Planned Change Request for Shielded Containers

Summary

Figure 1

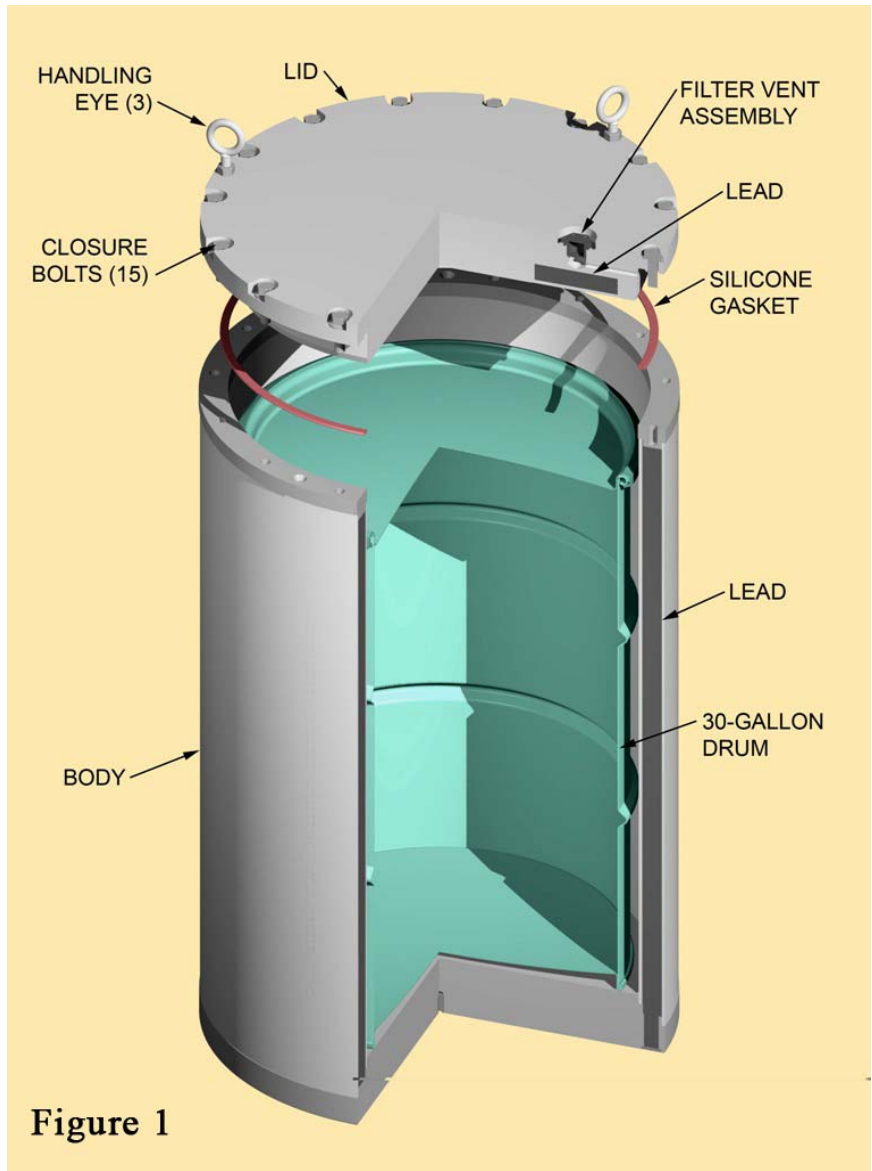
The shielded container has approximately the same exterior dimensions as a 55-gallon drum and is designed to hold a 30-gallon drum. The cylindrical sidewall of the shielded container has 1-inch thick lead shielding sandwiched between a double-walled steel shell as shown in Figure 1. The external wall is 1/8 inch thick, and the internal wall has a thickness of 3/16 inch. The lid and the bottom of the container are made of carbon steel and are 3-in thick. The empty weight of the containers is approximately 1,800 pounds. The shielded container and the inner 30-gallon drum will be vented. The container has been tested to DOT Type 7A and NRC Type B Hypothetical Accident Conditions (HAC) specifications. This will ensure the container is safe for transport and handling and will contain and shield the waste under the most severe accident conditions.

Figure 2

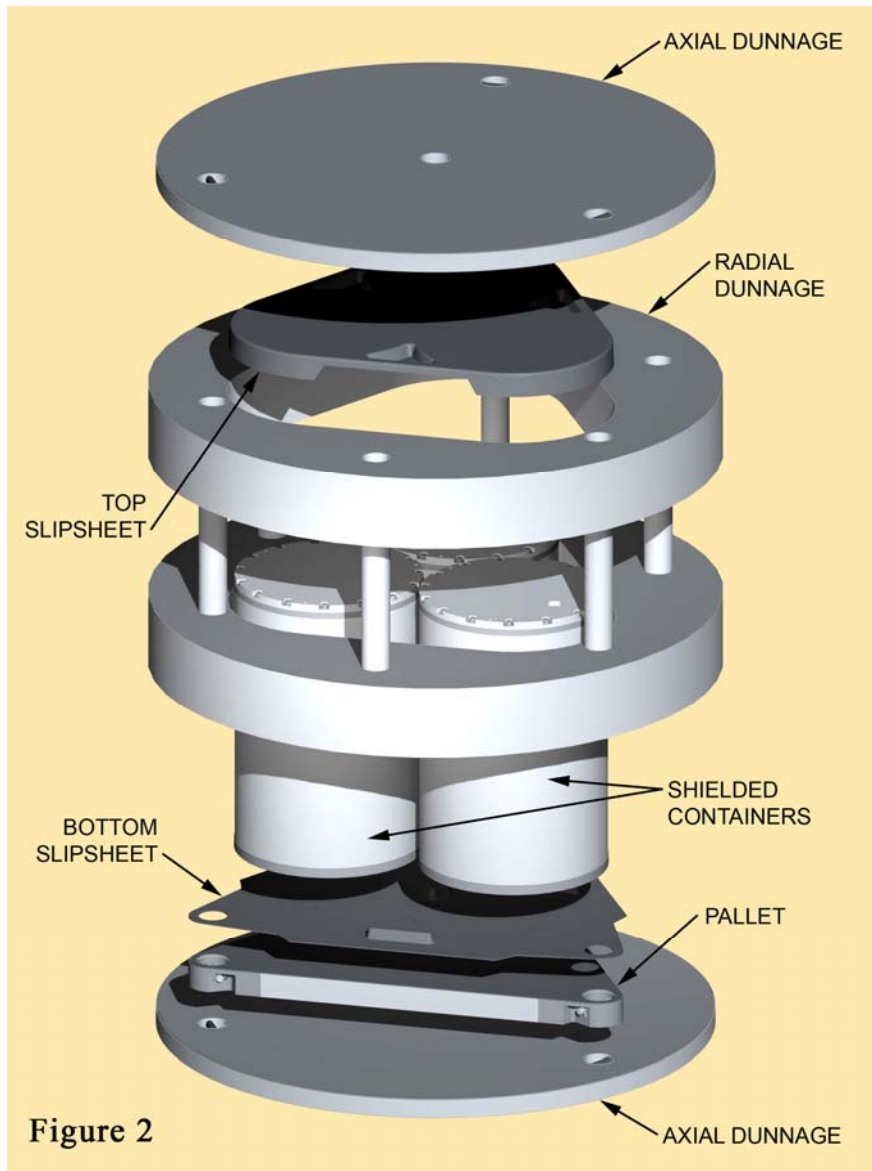
The shielded containers will be assembled in a 3-pack configuration on a triangular pallet, be surrounded by radial and axial dunnage components, and be transported within the existing HalfPACT transportation container. The 3-pack configuration will remain intact throughout transportation and emplacement (Figure 2). The shielded container is designed to stay within the parameters of the HalfPACT design and licensing bases e.g., payload weight, decay heat and radiation dose rate limits. To ensure the robustness of the container, it was subjected to DOT 7A Type A testing that included 4 foot drops of the bare container onto an unyielding surface using four potentially worse-case orientations. As part of the safety analysis, a 3-pack of containers was drop tested 30-feet inside a HalfPACT ICV (Inner Containment Vessel) as part of the Hypothetical Accident Condition (HAC) evaluation required by Title 10 CFR Part 71. The HAC tests evaluate and ensure the containers will adequately shield the RH TRU waste contained within under the most severe accident conditions. The thermal, shielding and criticality evaluations were performed by analysis using similar methodology as presented in the HalfPACT Safety Analysis Report (SAR), RH-TRU 72-B SAR and the TRUPACT II SAR. The tests were successful and the results will be used to demonstrate compliance with all applicable DOT and NRC standards, ultimately leading to certification of the payload container as a DOT 7A, Type A container and as an authorized payload container for shipment within the NRC certified HalfPACT Type B Packaging. DOE is awaiting regulatory approval. The success of this testing proved the container is safe even after being subjected to worst case severe handling or accident condition impacts as specified within the DOT and NRC regulations.

Figure 3

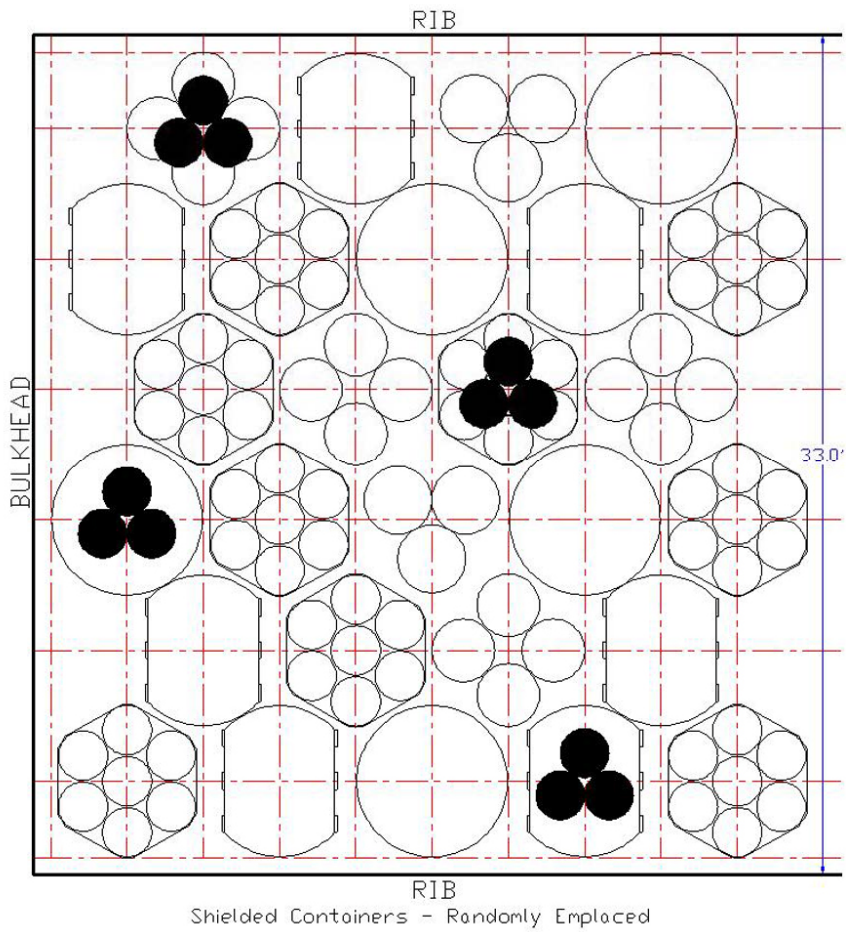
The SCPA used a bounding approach to model the effects of waste in shielded containers. The baseline scenario (SCPA scenario 1) assumes that all of the RH TRU waste is emplaced in canisters in the walls of the repository. SCPA scenario 2 assumes that all of the RH TRU waste is emplaced in shielded containers, rooms of the repository. No other changes were made to the PA baseline for this scenario. SCPA scenario 3 assumes that half of the RH TRU waste is emplaced in shielded containers in the rooms of the repository and half of the RH TRU waste is emplaced in canisters in the walls of the repository. No other changes were made to the PA baseline for this scenario. A comparison of the results from SCPA scenario 2 and SCPA scenario 3 to the baseline estimates of releases in SCPA scenario 1 identified the effects of the emplacement of shielded containers on repository performance. As described below, the effect was not discernable.
